CITY OF WESTMINSTER			
PLANNING APPLICATIONS SUB COMMITTEE	Date 12 May 2020	Classification For General Release	
Report of Director of Place Shaping and Town Planning		Ward(s) involved Warwick	
Subject of Report	69C Gloucester Street, London, SW1V 4EA		
Proposal	Installation of new windows and a replacement door within the lightwell, in connection with the amalgamation of the front vaults into existing lower ground floor flat, and associated alterations.		
Agent	Turley		
On behalf of	FND Group		
Registered Number	19/10035/FULL	Date amended/ completed	20 December 2019
Date Application Received	20 December 2019		
Historic Building Grade	Unlisted		
Conservation Area	Pimlico

- Address:** 69C Gloucester Street, London, SW1V 4EA
- Proposal:** Installation of new windows and a replacement door within the lightwell, in connection with the amalgamation of the front vaults into existing lower ground floor flat.
- Reference:** 19/10035/FULL
- Plan Nos:** Site Location Plan; AP100 rev 00; AP110 rev 00; AP111 rev R00; AP121 rev R00; AP200D rev R01; AP211D rev R02; AP213 rev R0; AP221D rev R0; AT500 rev R00; AT501 rev 00; Design and Access Statement (dated Dec 2019); Cover Letter (dated 20 Dec 2

Existing (above) and Proposed (below) Return Lightwell Elevation

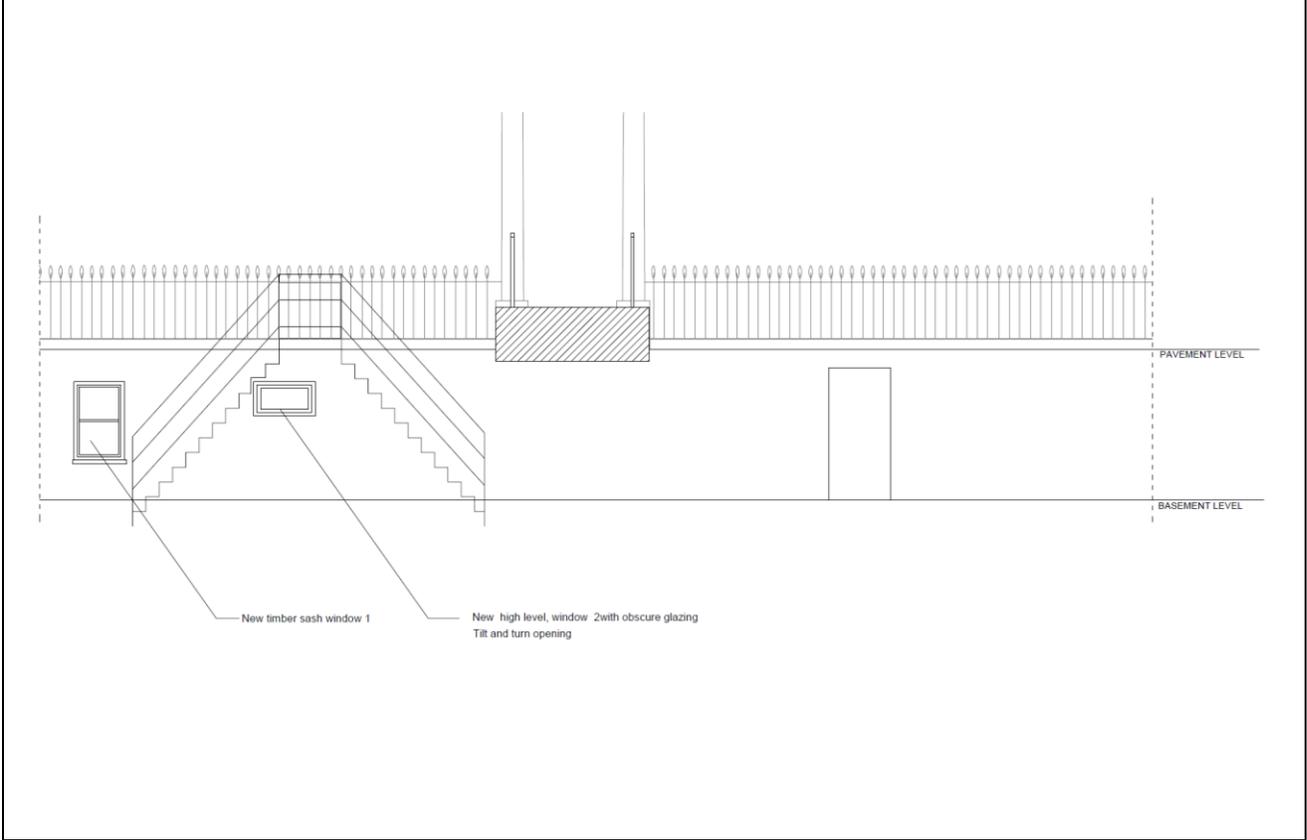
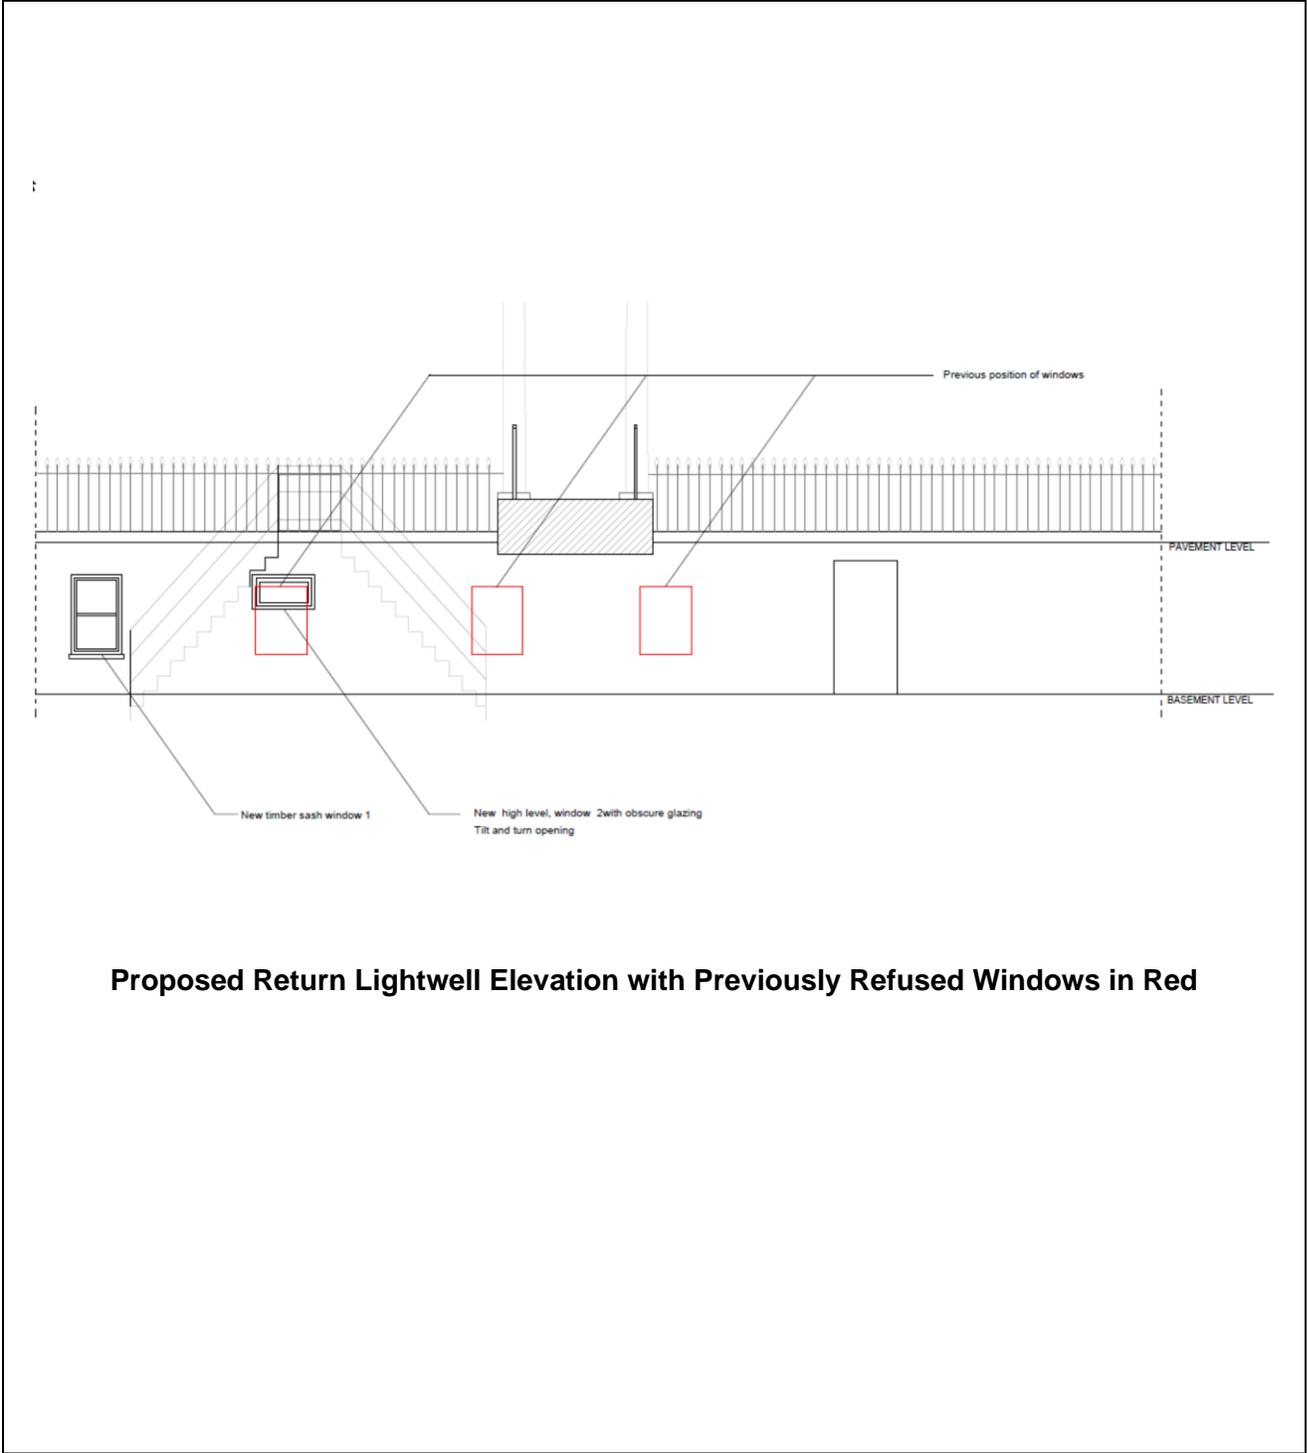
The current application has removed two of the previously proposed windows and amended a third to be a smaller high level window. This means that from the living room of 69B Gloucester Street (the room on the corner of the building) the new windows would not be visible because of the extremely acute angle between these locations and because the external staircase within the lightwell would obscure it. From the bedroom, which is adjacent to the application flat and closer to the new windows, some glimpsed views of the new high level window may be possible in a small portion of the bedroom. However, given this new window would be small, high level, have obscure glazing and not visible in a significant majority of the bedroom this would not be harmful to the amenity of the residents such that a refusal on that basis could be justified. The other new sash window and door are further from the neighbour so would have no impact.

- 5 The glass that you put in the windows in the return elevation of the lightwell must not be clear glass. You must apply to us for approval of a sample of the glass (at least 300mm square). You must not start work on the relevant part of the development until we have approved the sample. You must then fit the type of glass we have approved and must not change it without our permission. (C21DB)

Proposed Return Lightwell Elevation with Previously Refused Windows in Red

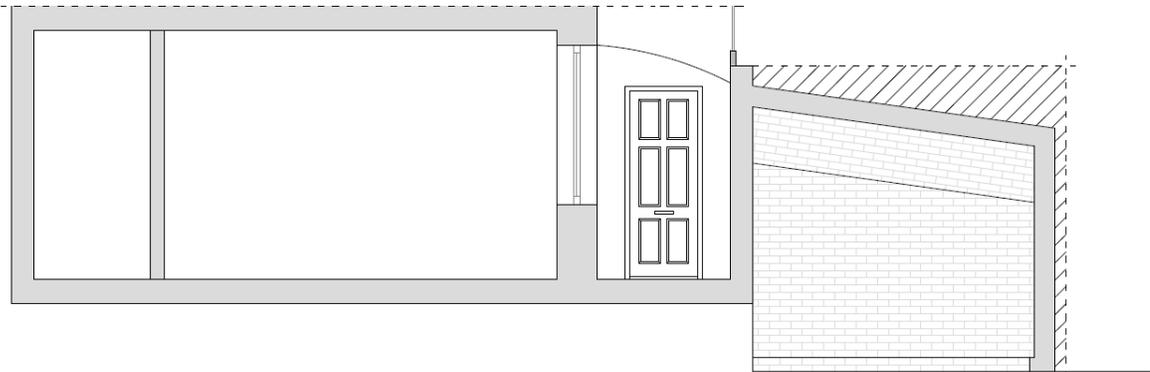
In February 2019, officers concluded the new windows proposed in that application would be unacceptable because they would have resulted in a significant increase in a sense of overlooking and light spill harmful to the occupier of 69B Gloucester Street. These windows would have been sash windows and because of their number and positions, would have been visible from significant portions of the bedroom and living room at 69B Gloucester Street. They would not have been harmful to other occupiers in the building given the position of these neighbours relative to the new windows.
